Cleveland City Planning Commission

July 24, 2026

Agenda: July 24, 2026

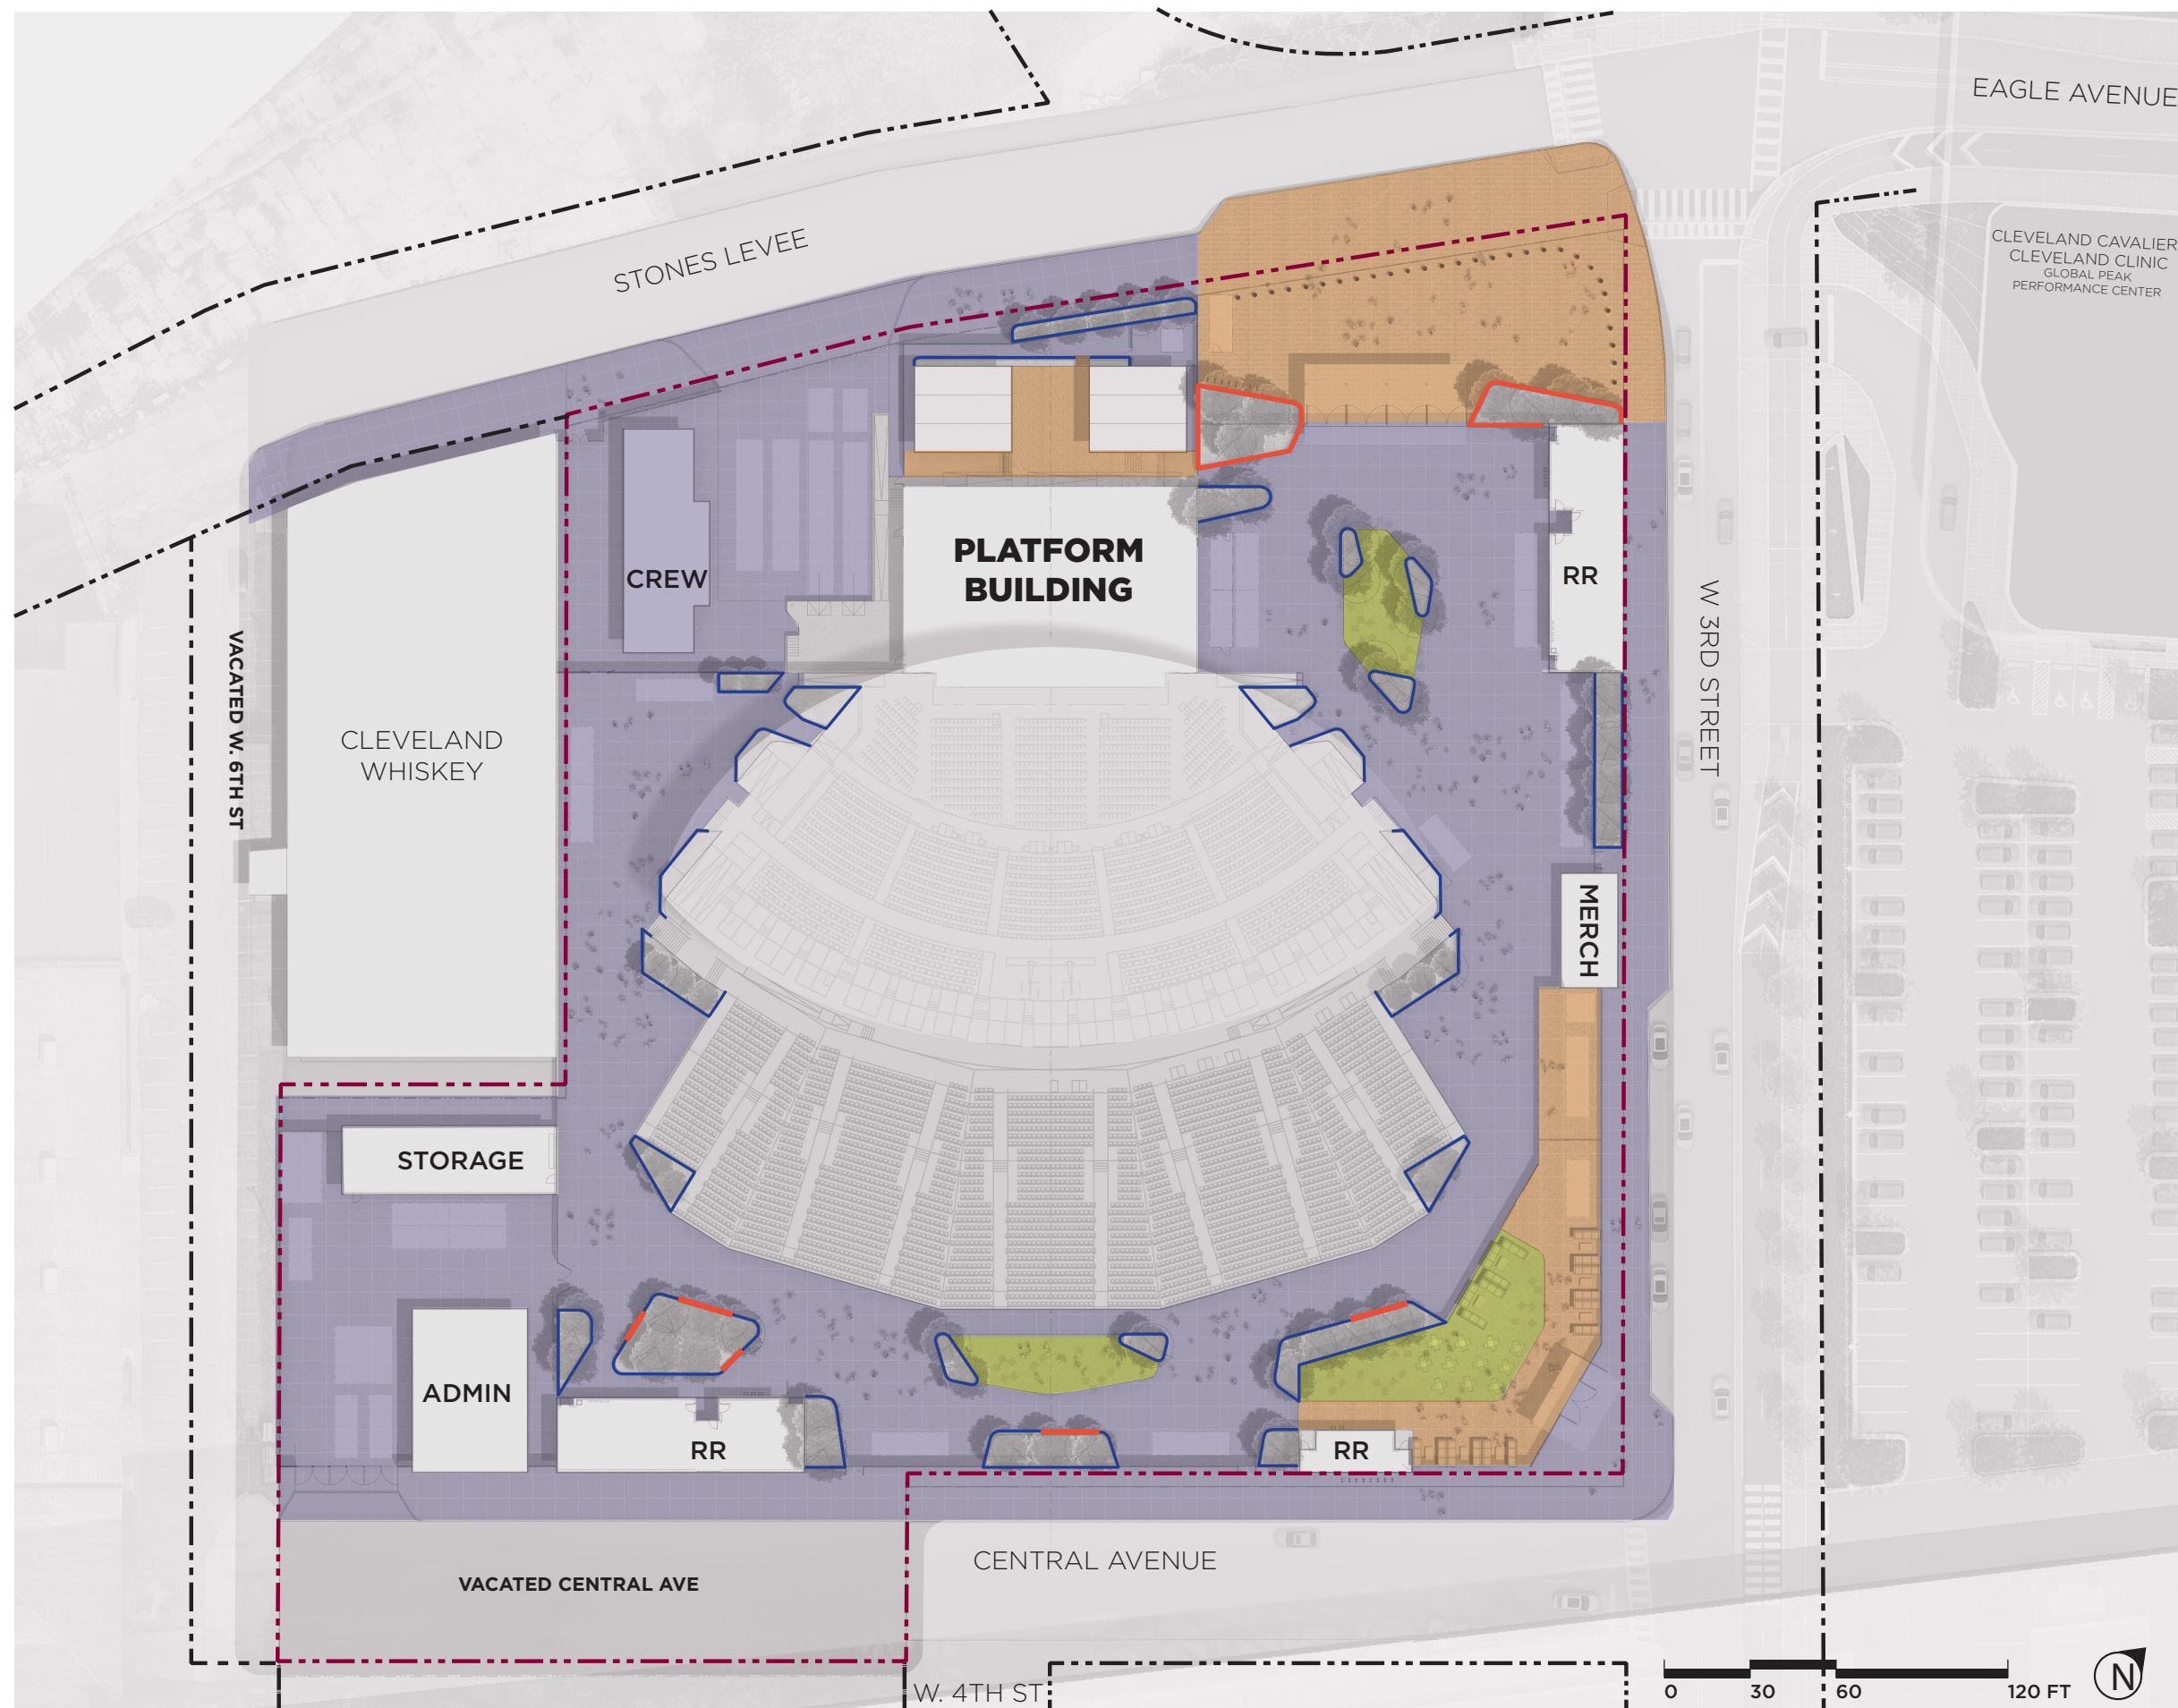
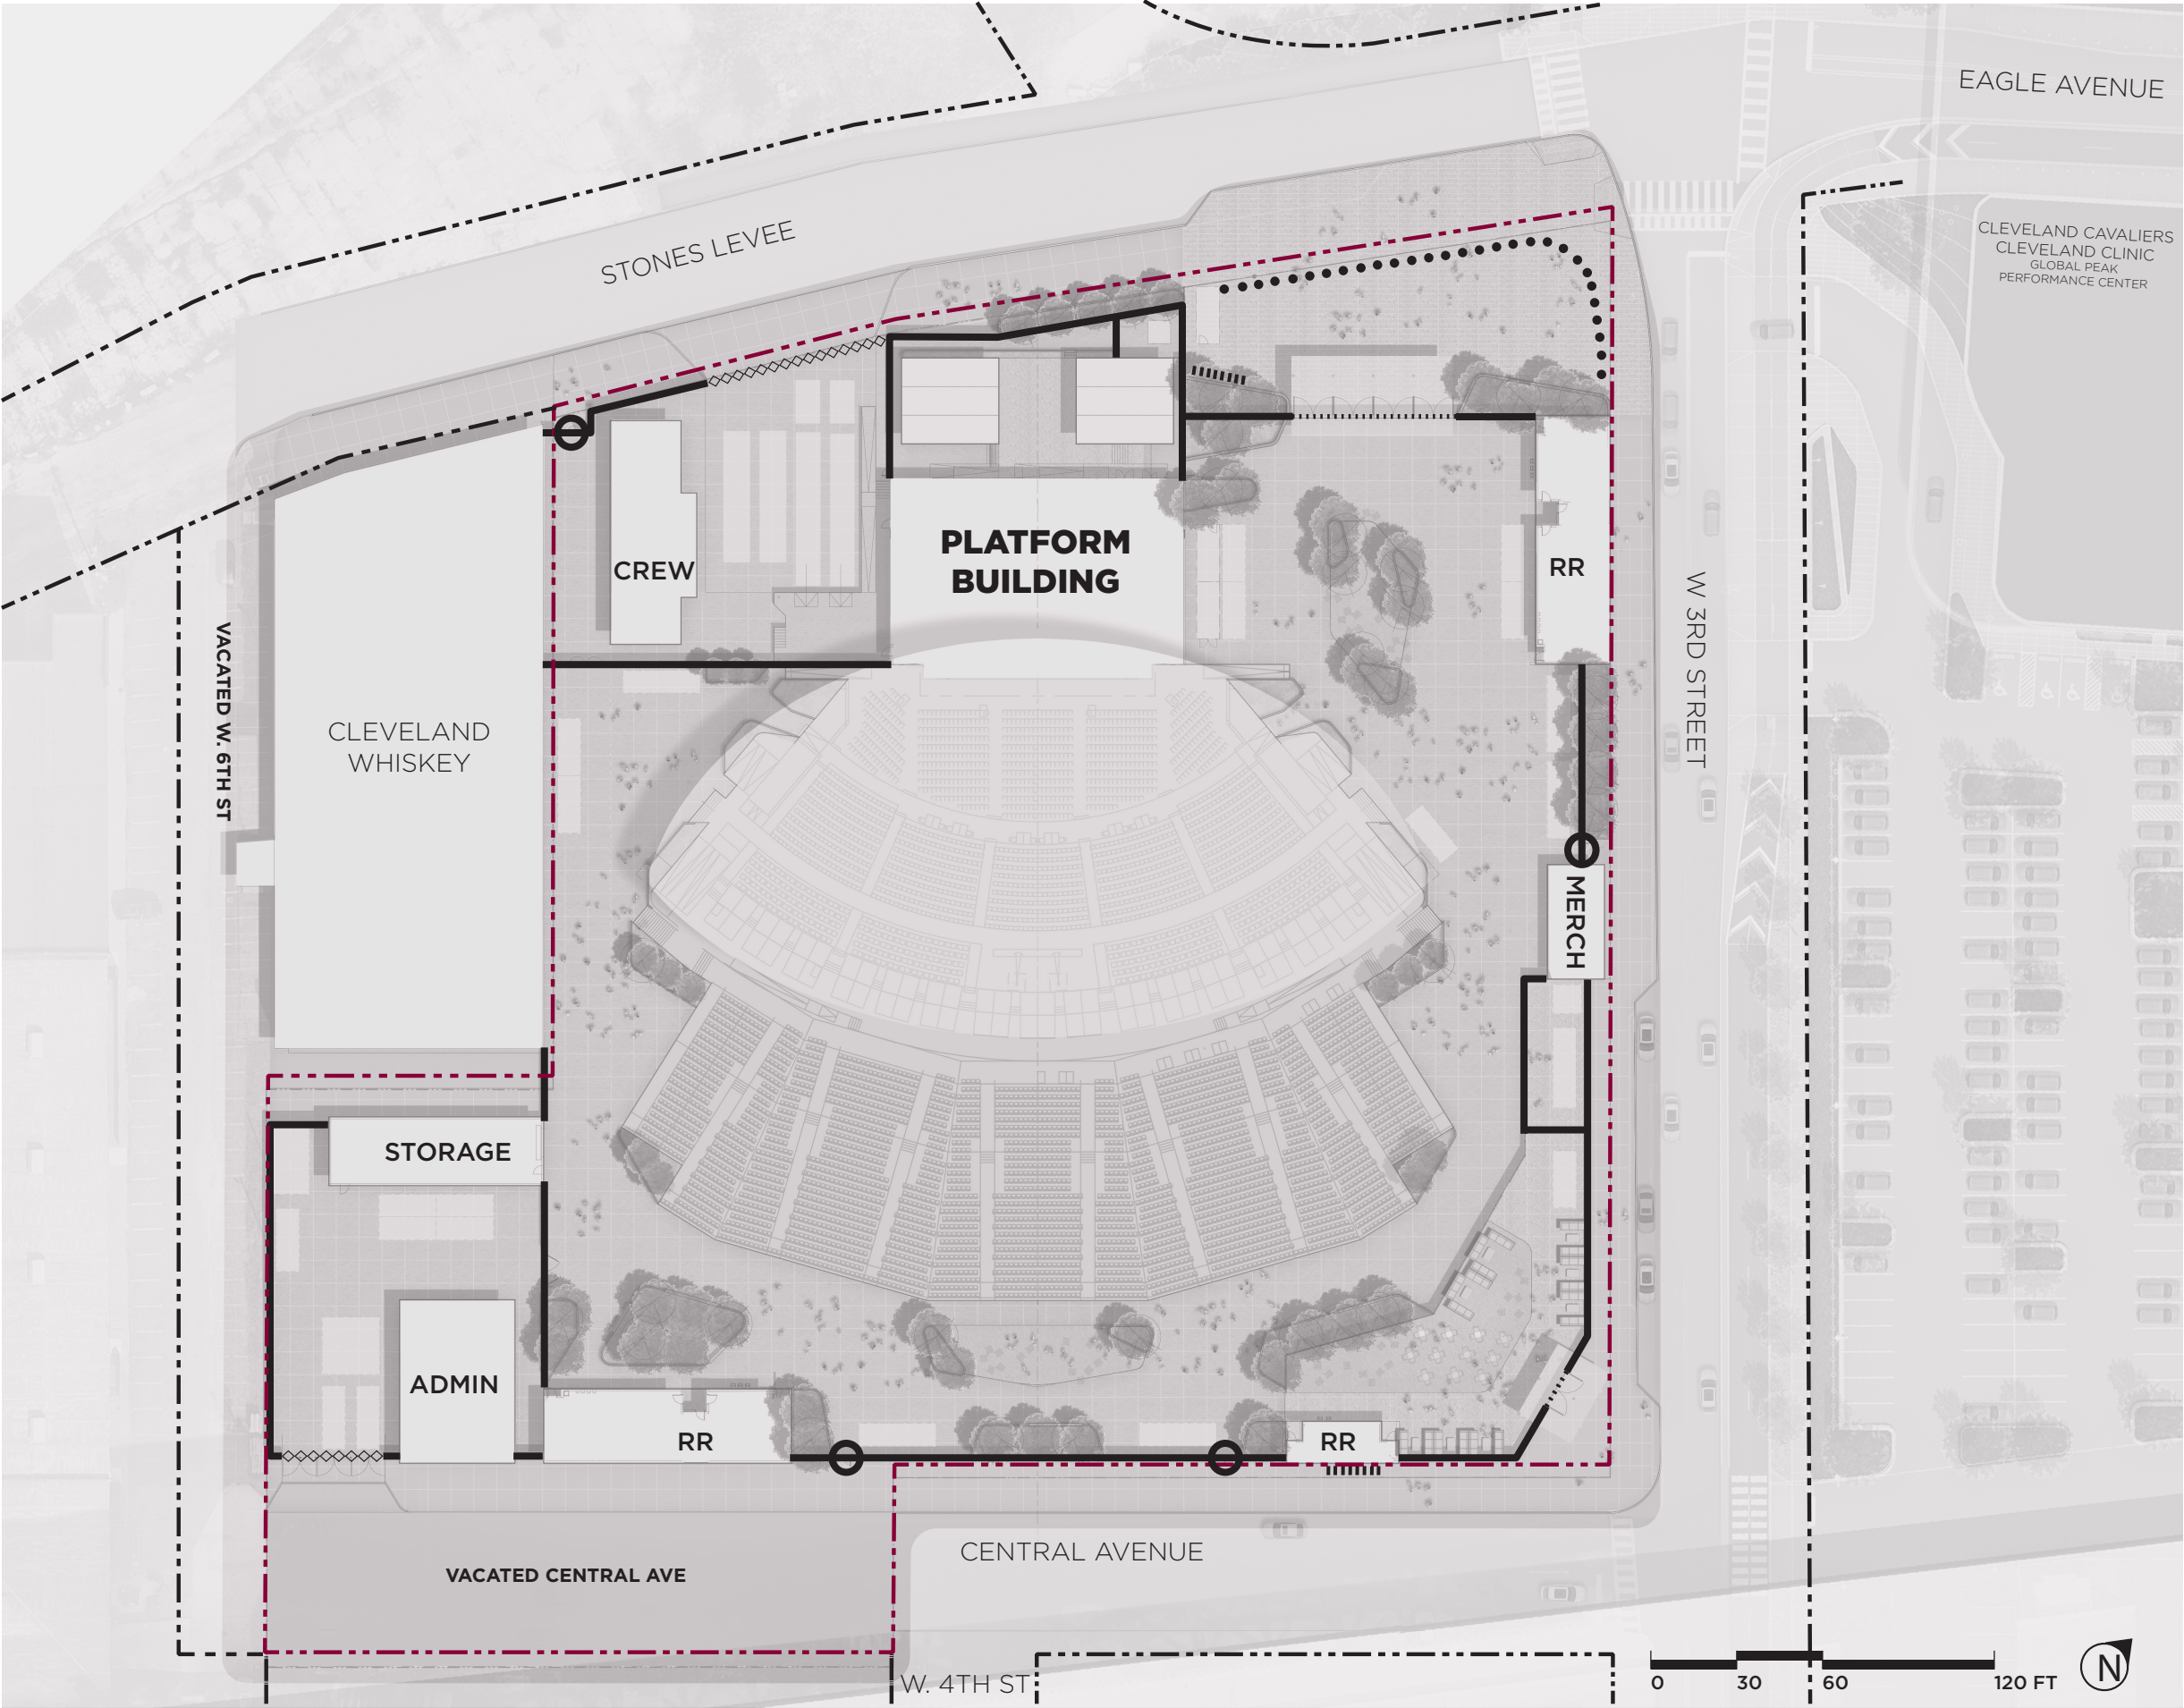
- 1) Provide further **transparency & pedestrian interaction for fencing treatment** at W.3rd St., and reconsider the use of dark metals where there is potential for contact with people [to avoid **burns**].

1. Provide further transparency & pedestrian interaction for fencing treatment at W.3rd St., and reconsider the use of dark metals where there is potential for contact with people [to avoid burns].
